**TOWN OF MOUNTAIN VILLAGE
REGULAR DESIGN REVIEW BOARD MEETING
THURSDAY OCTOBER 3, 2019 10:00 AM
2nd FLOOR CONFERENCE ROOM, MOUNTAIN VILLAGE TOWN HALL
455 MOUNTAIN VILLAGE BLVD, MOUNTAIN VILLAGE, COLORADO
REVISED AGENDA**

TO: Design Review Board
FROM: Sam Starr, Planner
FOR: Meeting of October 3rd, 2019
DATE: September 26, 2019
RE: Design Review: Final Review for a new single-family home on Lot BC105,114 Lawson Overlook

TO: Design Review Board
FROM: Sam Starr, Planner
FOR: Meeting of September 5, 2019
DATE: September 26, 2019
RE: Initial Architectural and Site Review for a new single-family home on Lot AR-53R2, 125 Adams Way

PROJECT NAME: BC 105
MOUNTAIN VILLAGE
COLO. 08400 81435
SHEET DESCRIPTION: CONSTRUCTION STAGING PLAN
SHEET NUMBER: A101

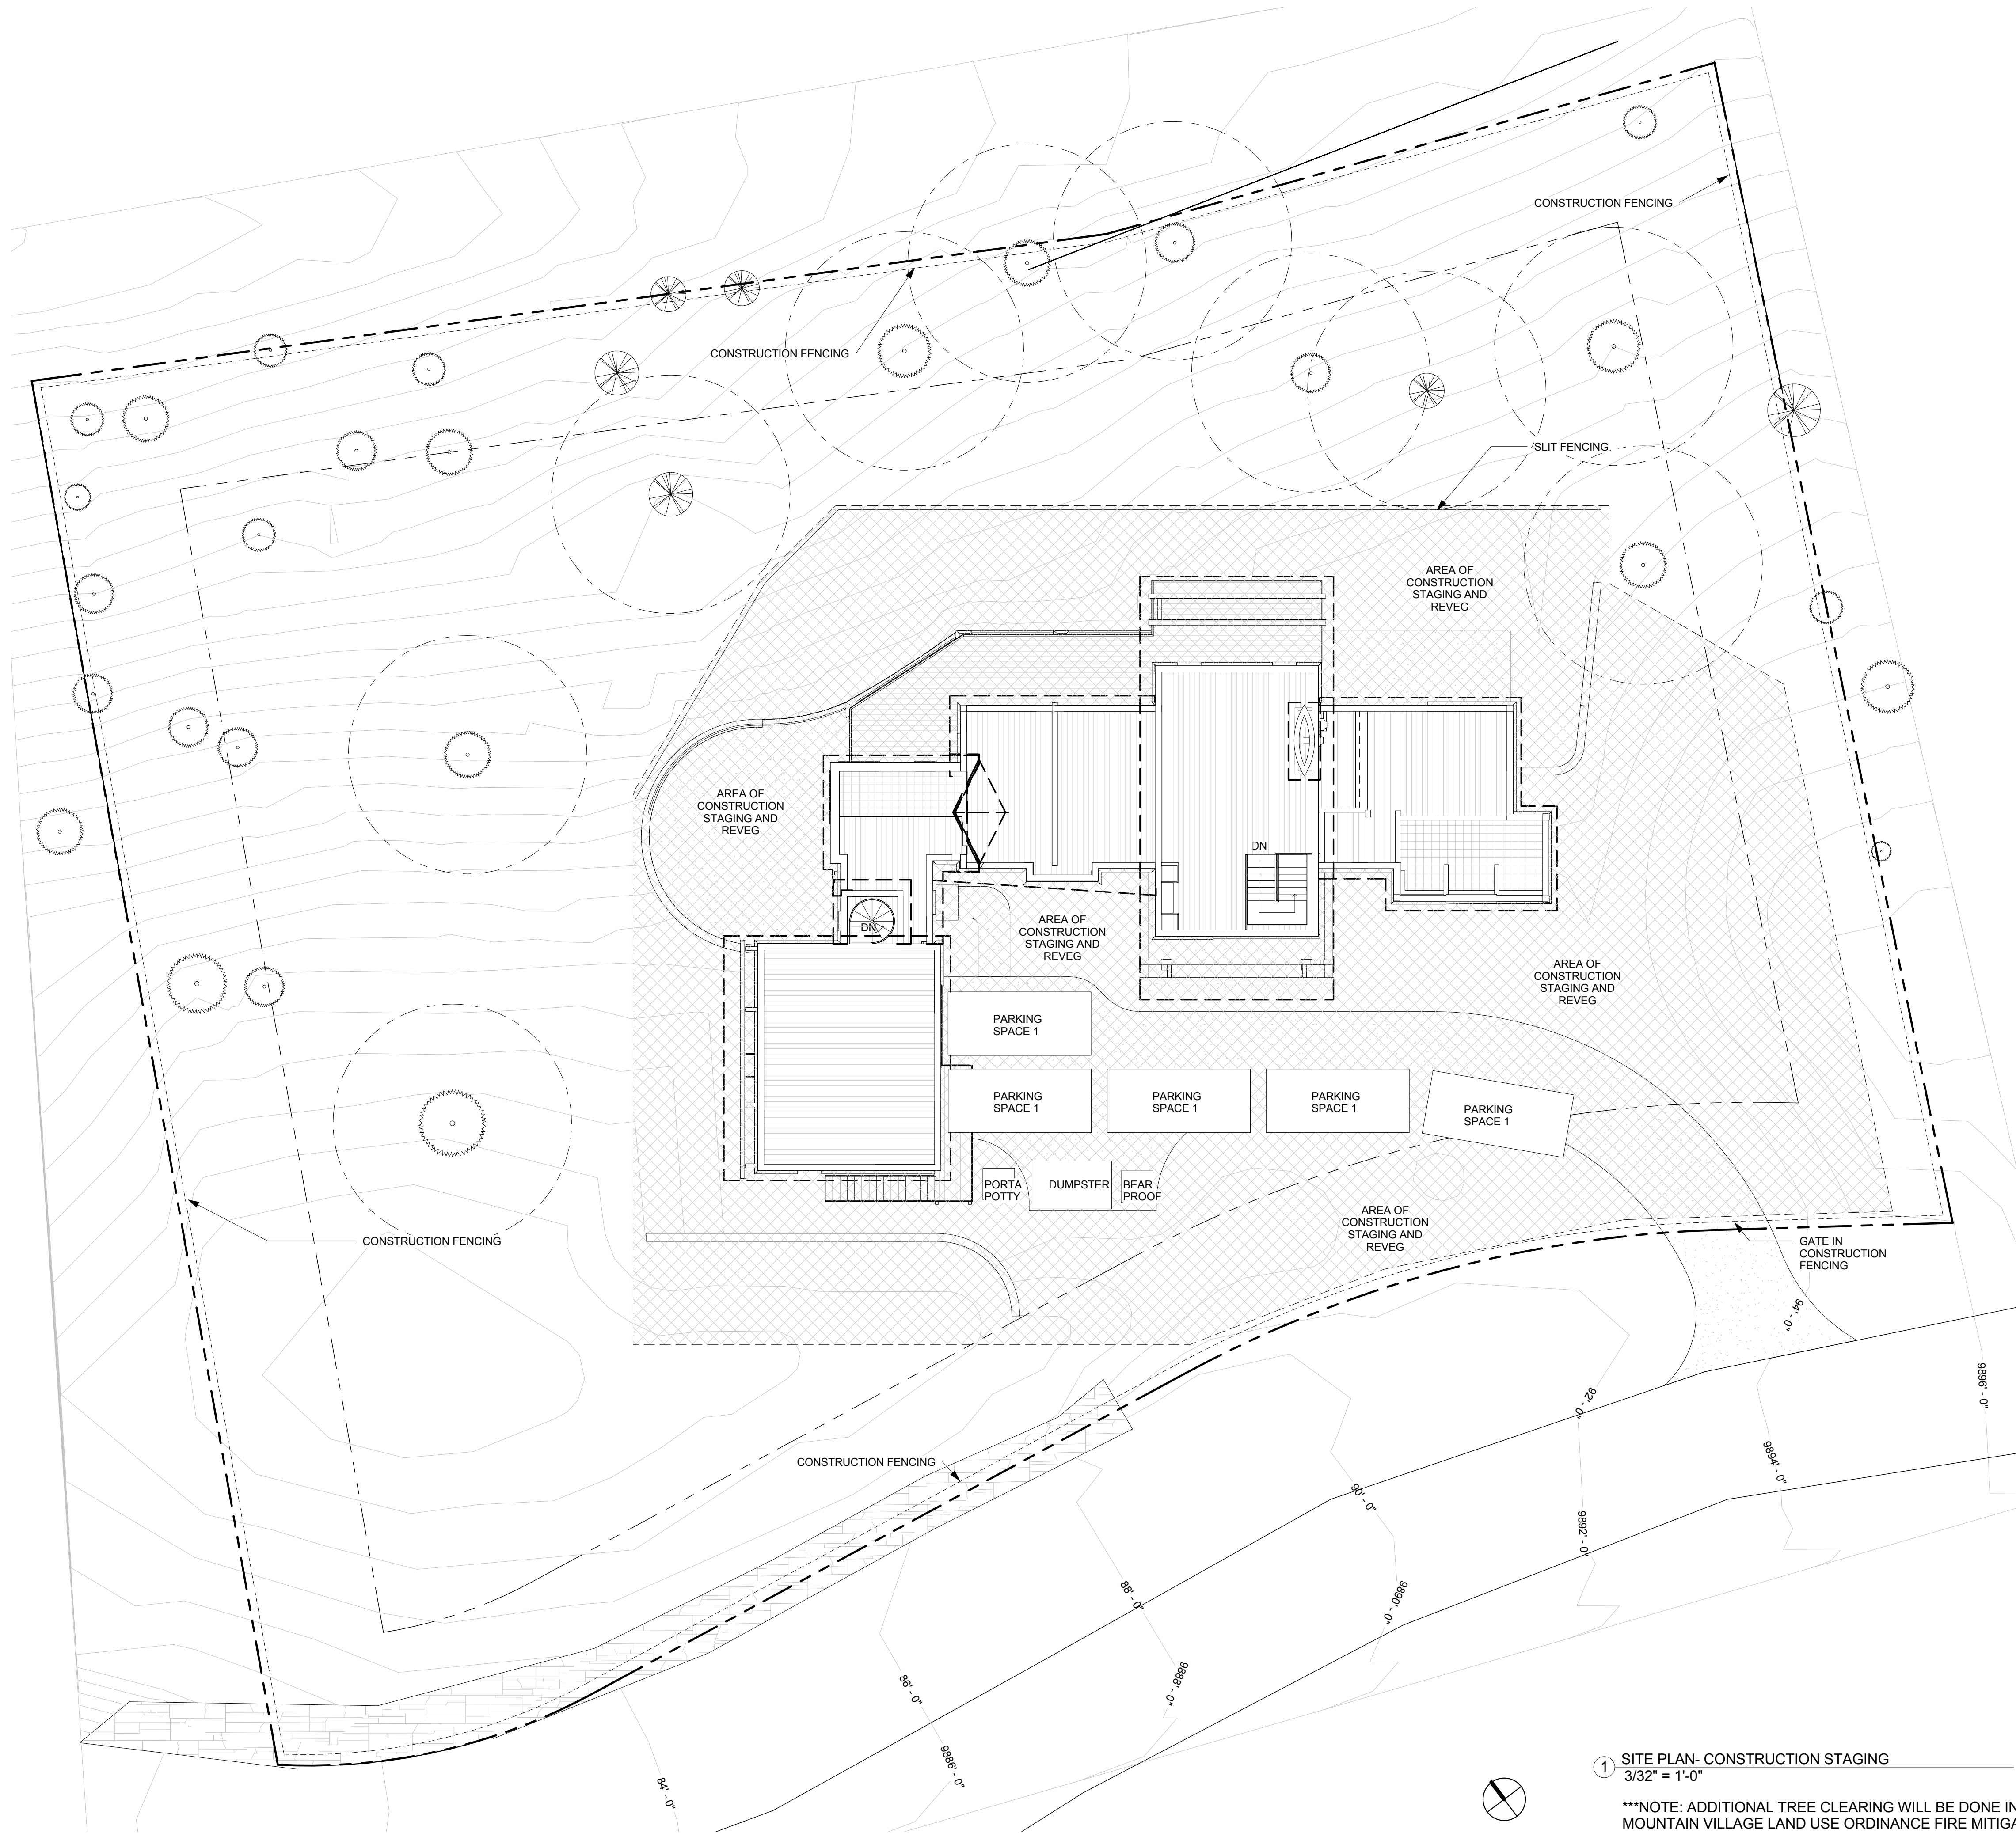
All construction staging is within the lot boundaries. Applicant has updated this plan to include perimeter fencing for the entire lot, and not just silt fencing on portions of the northern side. If the applicant disturbs any vegetation within the town owned General Easements, the applicant must revegetate the area to its previous condition. A condition for revegetation has been provided in the proposed motion.

SHEET DESCRIPTION: EXTERIOR LIGHTING PLAN

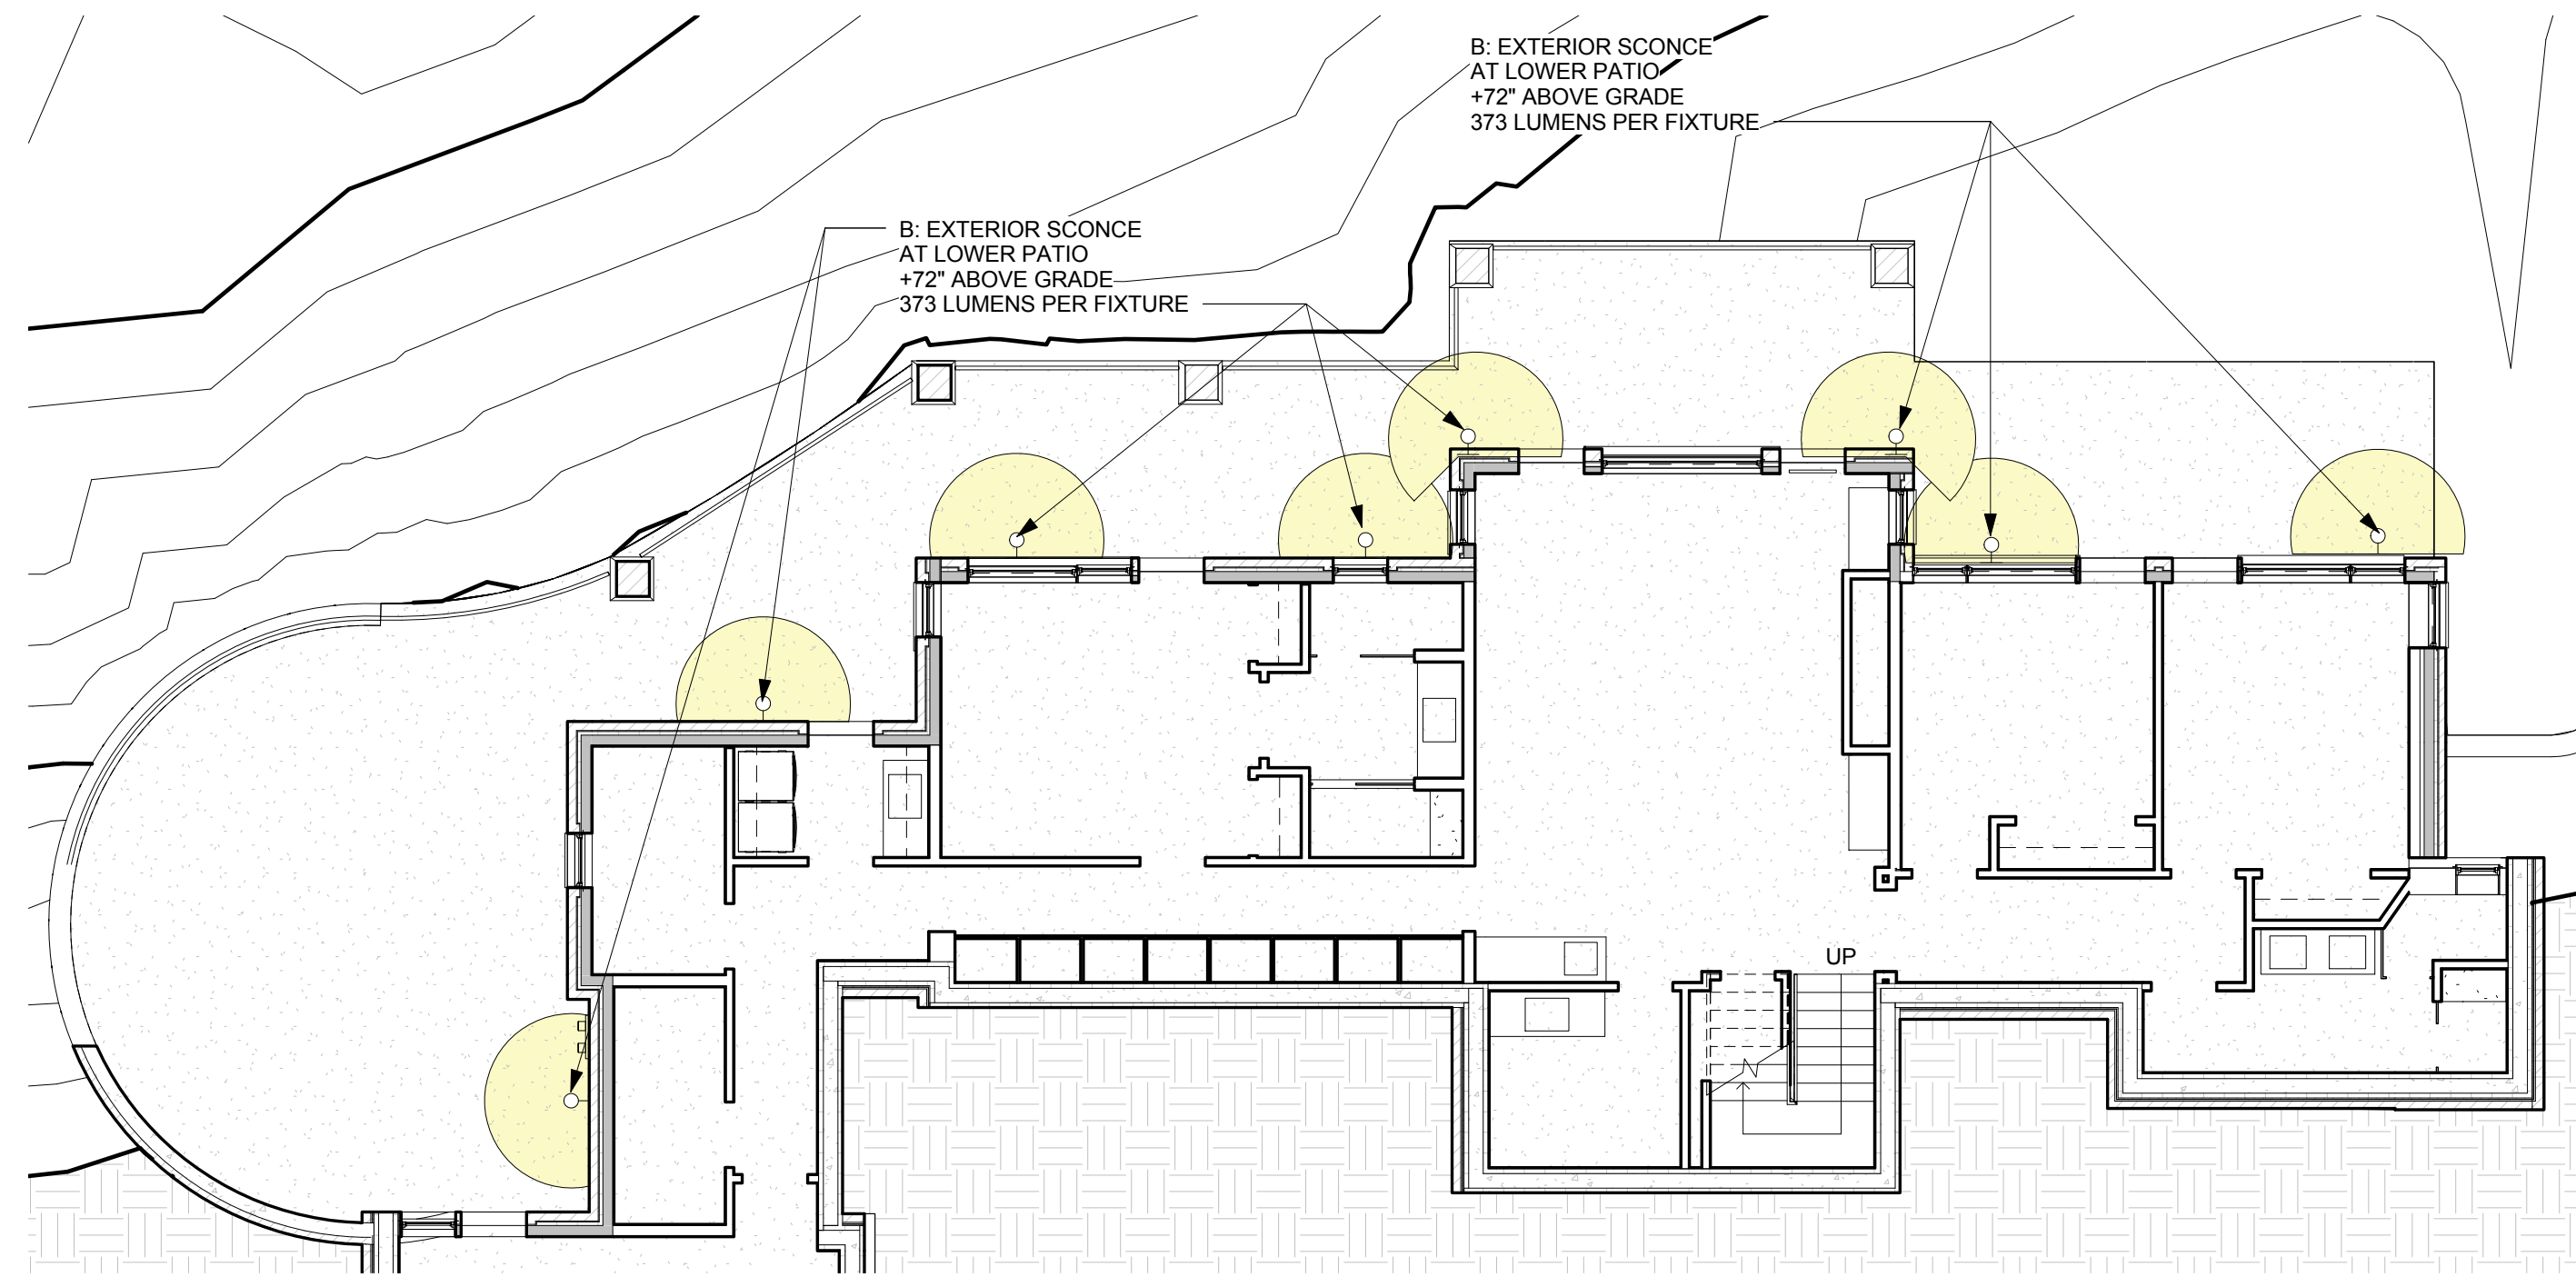
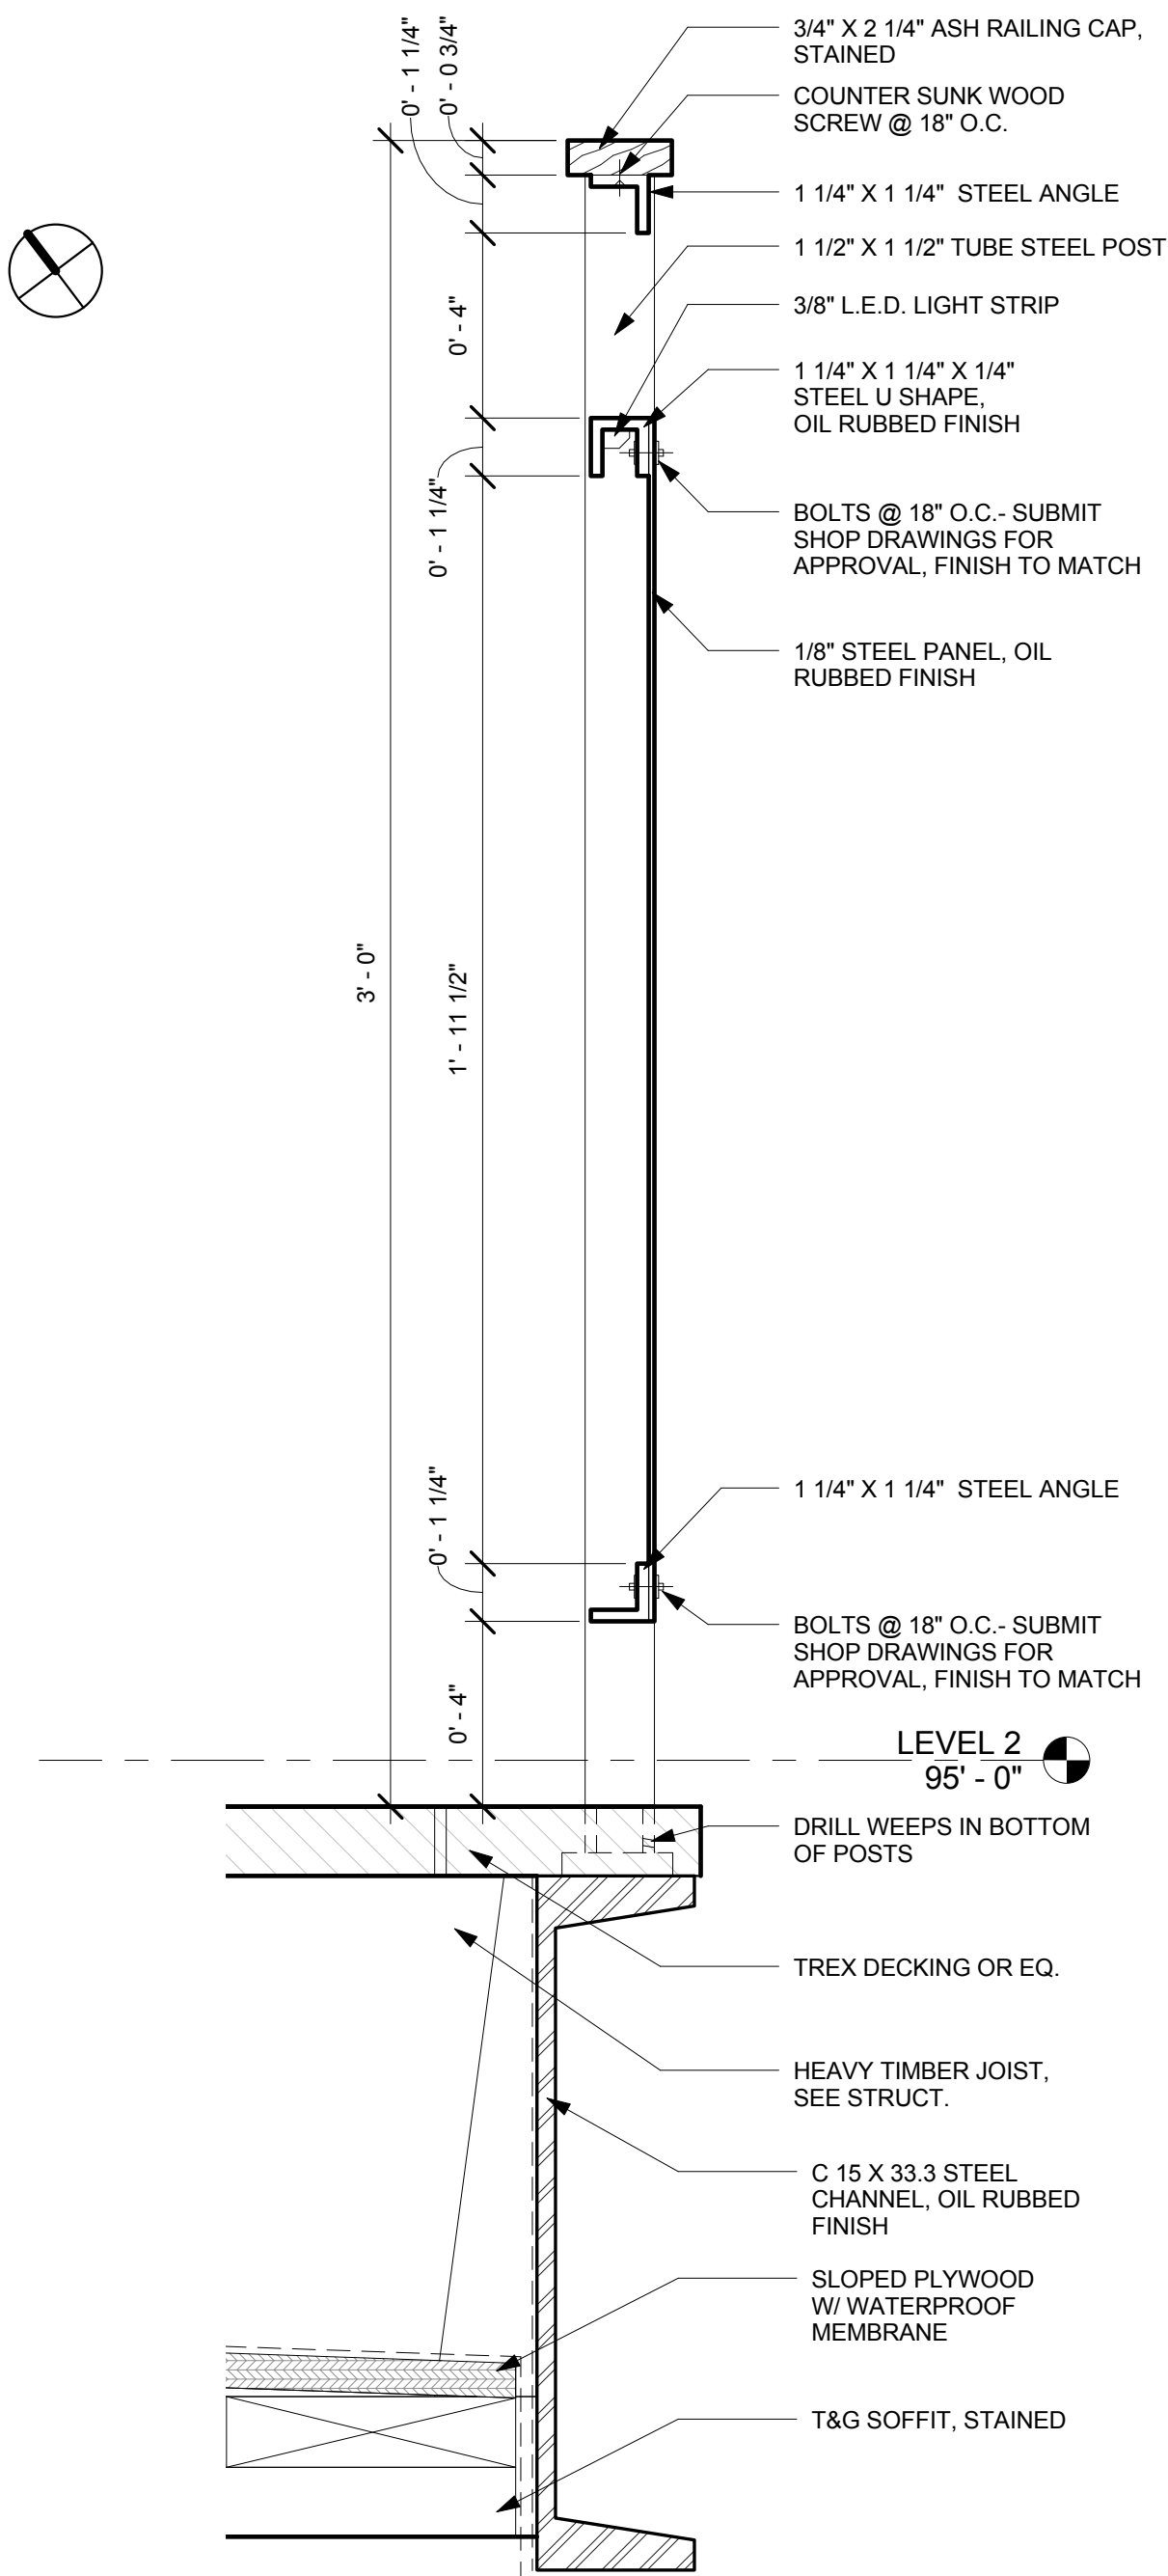
The revised lighting regulations include fewer lights, and the placement of lighting is code compliant. Proposed lighting locations include: decks, exterior egress areas, and the entryway. All fixtures meet the updated lumens and maximum temperature thresholds, and do not exceed the maximum allowed 84” in height. Staff recommends that an isometric foot candle study is prepared prior to issuance of a building permit to ensure that light spill does not occur on this site.

- 4. Applicant shall submit an exterior lighting plan prepared by a licensed professional that includes an isometric foot-candle diagram, and dimmer/lighting management system information to be reviewed by staff and DRB Chairperson or DRB Chairperson designate.*
